SUBJECT: ISSUANCE OF AMENDMENT (TAC NO. M89741)

The Commission has issued the enclosed Amendment No. 178 to Facility Operating License No. DPR-16 for the Oyster Creek Nuclear Generating Station, in response to your application dated June 22, 1994.

Amendment No. 178
License No. DPR-16

ATTACHMENT TO LICENSE AMENDMENT NO. 178

Fig. 3.2-1 Sodium Pentaborate Solution Volume - Concentration Requirement

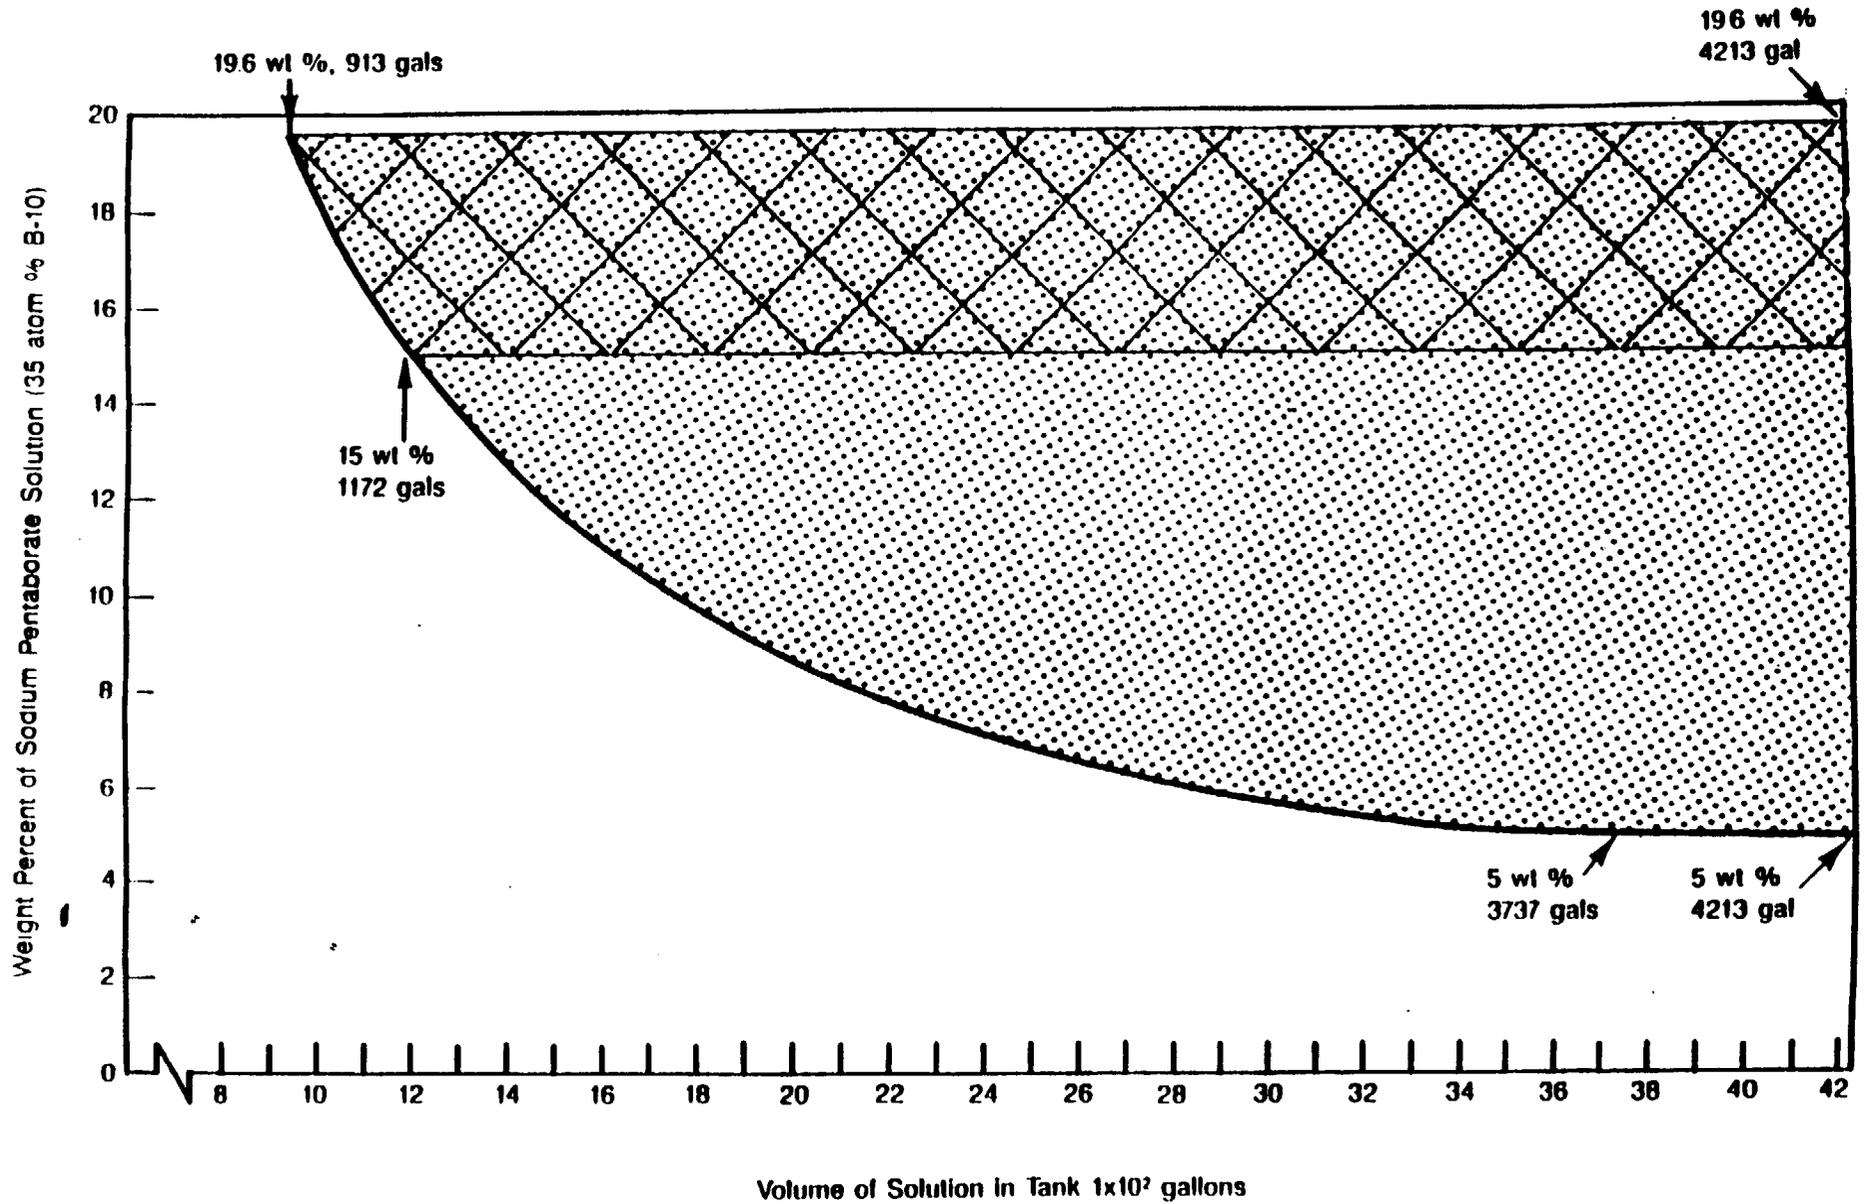
Figure 3.2.1 was revised to reflect the minimum and maximum weight percent of sodium pentaborate solution, and the minimum atom percent of B-10 to meet 10 CFR 50.62(c)(4). Since the weight percent of sodium pentaborate can change with water makeup or water evaporation, frequent surveillances are performed on the solution concentration, volume and temperature. The sodium pentaborate is enriched with B-10 at the chemical vendor's facility to meet the minimum atom percent. Preshipment samples of batches are analyzed for B-10 enrichment and verified by an independent laboratory prior to shipment to Oyster Creek. Since the B-10 enrichment will not change while in storage or in the SLCS tank, the surveillance for B-10 enrichment is performed on a 24 month interval. An additional requirement has been added to evaluate the solution's capability to meet the original design shutdown criteria whenever the Boron-10 enrichment requirement is not met.

- The standby liquid control solution shall have a Boron-10 isotopic enrichment equal to or greater than 35 atom %, be maintained within the cross-hatched volume-concentration requirement area in Figure 3.2-1 and at a temperature not less than the temperature presented in Figure 3.2-2 at all times when the standby liquid control system is required to be operable.

- (b) If the solution is outside the cross-hatched volume-concentration area but within the shaded volume-concentration area of Figure 3.2-1, return the solution to the cross-hatched area within 7 days. If, after this time period, the requirement is still not met, submit a report to the NRC within 7 days advising them of plans to return the solution to the cross-hatched volume-concentration area.

- (c) If the solution is outside the cross-hatched volume concentration area and outside the shaded volume-concentration area of Figure 3.2-1, return the solution to within the shaded volume-concentration area of Figure 3.2-1 or be in the Shutdown condition within 24 hours.
